Product Change Notice

Issue Date: 04-July-2023

To introduce lead to lead wire bonding to improve product's robustness towards moisture sensitivity

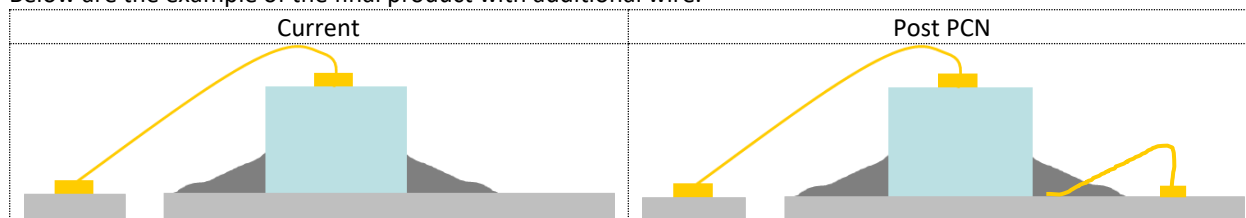
To add additional lead to lead wire under die attach epoxy

Below are the example of the final product with additional wire.
